“Full deskew” issue for Clause 177

Comment #54, #371

Introduction

Functional Block Diagrams in D1.2

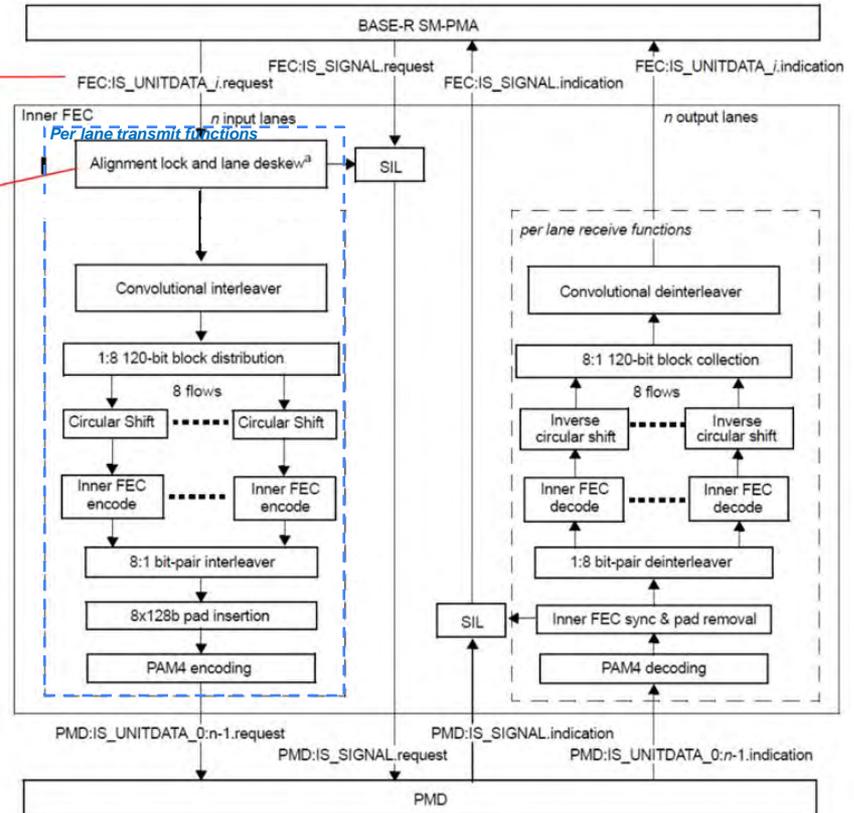
Incoming streams are 200G symbol-muxed (from the SM-PMA above)

Newly added “alignment lock and lane deskew” function (in response to comment #159).

- In order to perform the PCS lane deskew function the 200G input lanes would first have to be symbol-demuxed back to PCS lanes (essentially un-doing the symbol muxing of the SM-PMA layer above)
- Then deskew performed on the PCS lanes
- And finally, the PCS lanes symbol-muxed back to 200G lanes (repeating the function of the SM-PMA layer above).

Proposed New Functional Block Diagrams for 177.4.1

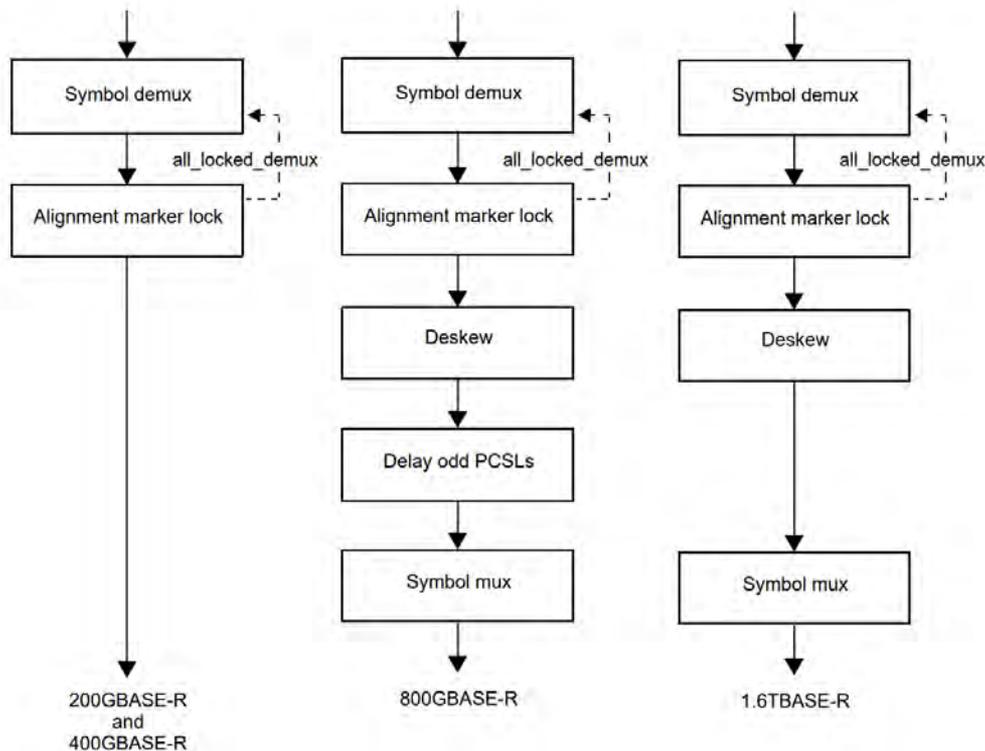
Three different processing flows are shown:

- For 200GBASE-R and 400GBASE-R, symbol-quartet boundary needs to be identified. However deskew and actual demux are not needed.
- For 800GBASE-R, alignment marker lock and deskew are needed, plus a 10-bit delay on odd lanes to remove the checkerboard pattern produced by PCS.
- For 1.6TBASE-R, alignment marker lock and deskew are needed.

177.4.1 Alignment lock and deskew

In order to maintain the full 12 RS-FEC codeword interleaving depth for the convolutional interleaver, alignment marker lock and deskew is provided.

Alignment marker lock is required to determine the RS-FEC 4-symbol and codeword boundaries. In addition, 800GBASE-R and 1.6TBASE-R PHYs must also deskew PCS lanes within each input lane and recombine the PCSLs for proper operation of the convolutional interleaver.
